FINAL
Environmental Impact Report
City of Pleasanton 2023-2031 (6th Cycle) Housing Element Update
City of Pleasanton, Alameda County, California

State Clearinghouse Number 2022040091

Date: January 3, 2023

SECTION 2: RESPONSES TO WRITTEN COMMENTS

VALLEY PLAZA SITE

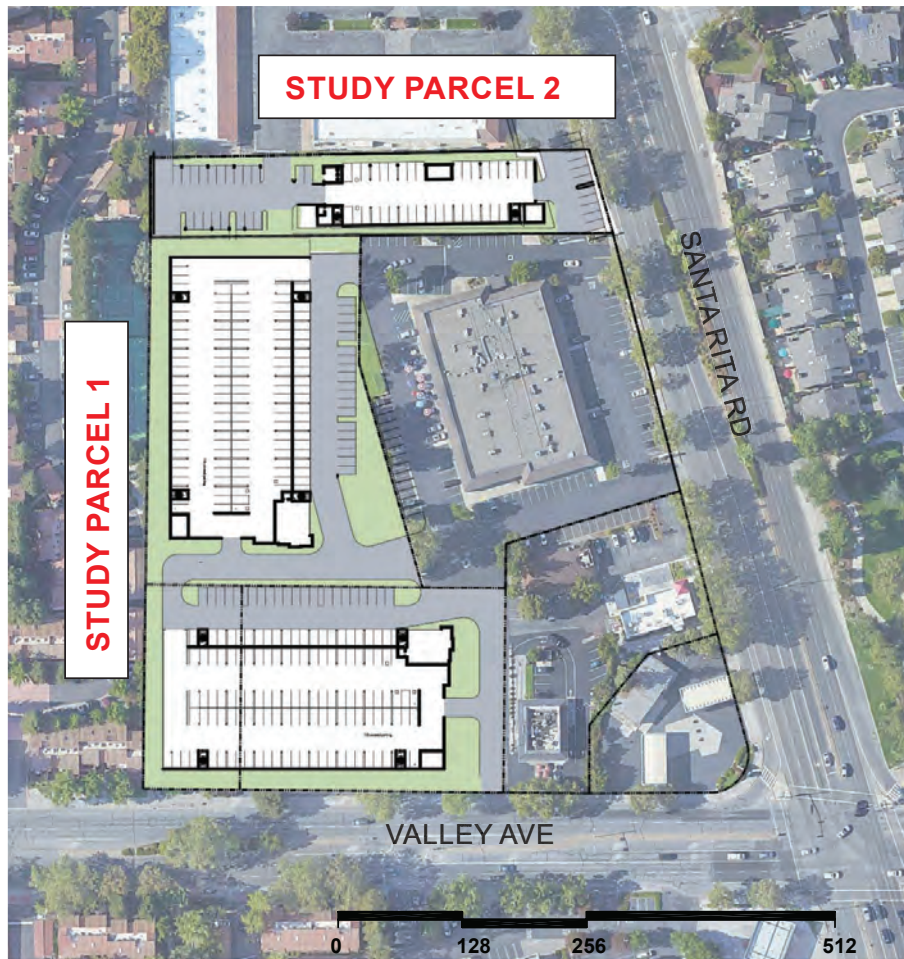
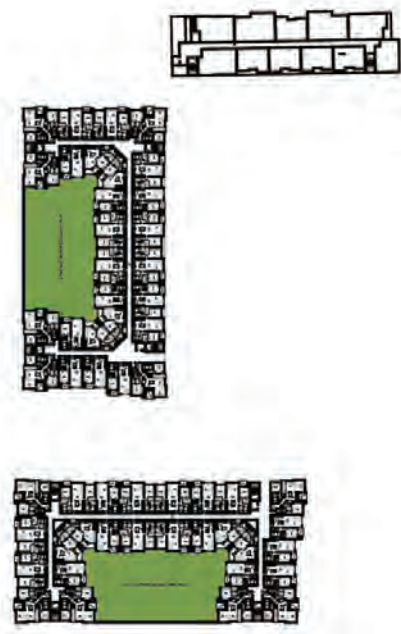
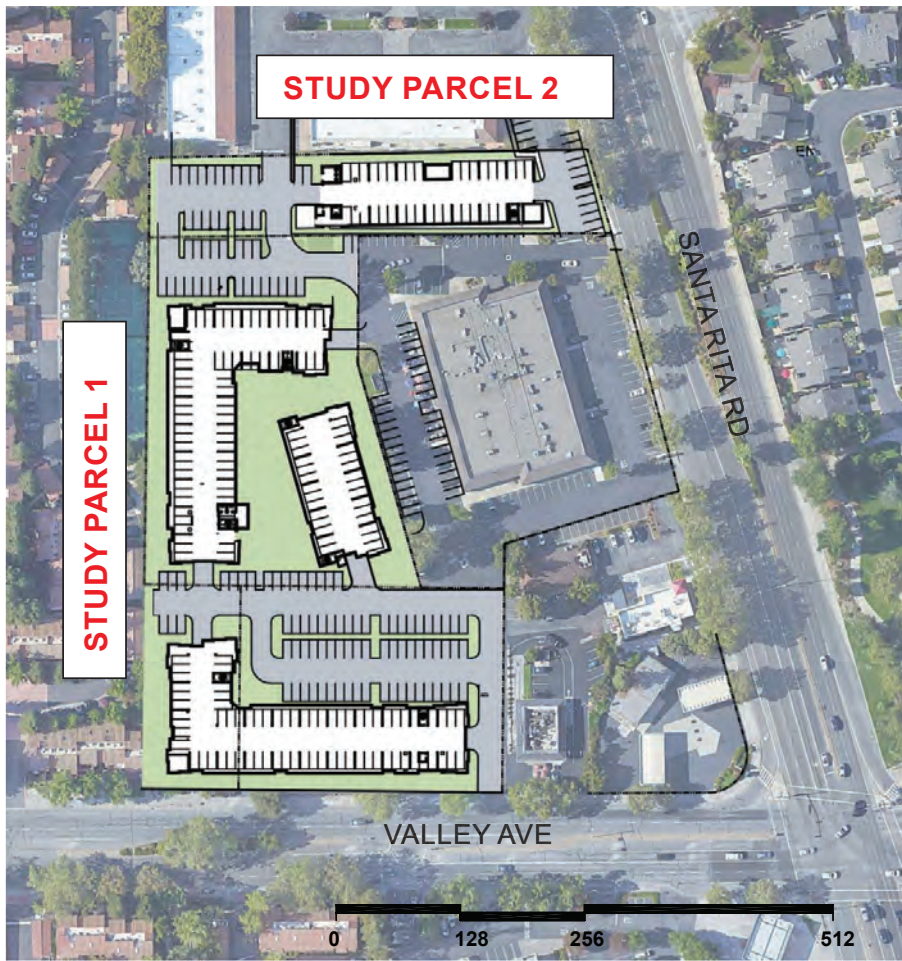
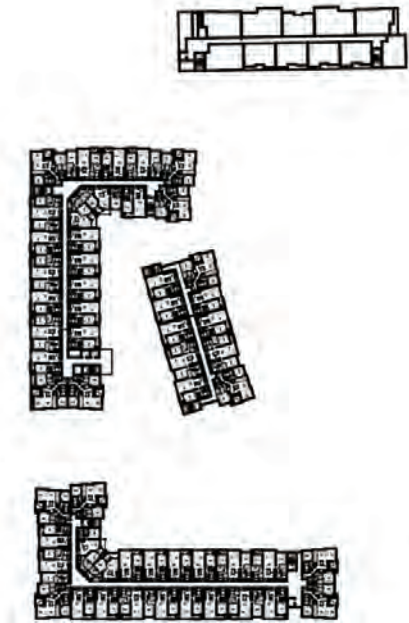
In response to community interest, the owners of the Mission Plaza removed their property from consideration in its entirety and Valley Plaza has retained a core commercial base into their draft plan. See attached draft plan for reference.

The commenter asserts that Site 18 (Valley Plaza) should be included as one of the sites included in the Remove Select Industrial and Commercial Sites Alternative (Alternative 1). The commenter provides a draft plan for Site 18 (Valley Plaza, see Attachment B of the comment letter), which is included in this Final EIR as CALIFORNIA GOLD-6.

Pursuant to CEQA Guidelines Section 15126.6, the City, in its discretion as the Lead Agency, chose alternatives that would (1) accomplish most of the basic goals and objectives of the Housing Element Update, including accommodating the Regional Housing Needs Assessment (RHNA); (2) would lessen the identified significant and unavoidable environmental effects of the Housing Element Update; and (3) would be feasible considering site suitability, available of infrastructure, general plan consistency, and consistency with other applicable plans and regulator limitations. As described in Chapter 6, Alternatives, the analysis of alternatives to the proposed Housing Element Update provides full disclosure and allows decision-makers to consider the proposed Housing Element Update in light of hypothetical alternative development scenarios. In compliance with CEQA Guidelines Section 15126.6, the sites included in each Build Alternative were chosen by the City to provide adequate sites to meet the RHNA, while reducing potential environmental impacts in light of relevant factors such as site constraints and market conditions. Therefore Site 18 (Valley Plaza) was not included in the Remove Select Industrial and Commercial Sites Alternative (Alternative 1) because of site constraints and market conditions. Further, this alternative was formed in an effort to exclude sites with zoning that currently allows light industrial and retail commercial to preserve these uses on-site. This reflects community concerns about the loss of local-serving retail such as the existing uses on Site 18 (Valley Plaza).

This comment is a draft plan for Valley Plaza. It is included in this comment letter as Attachment B.
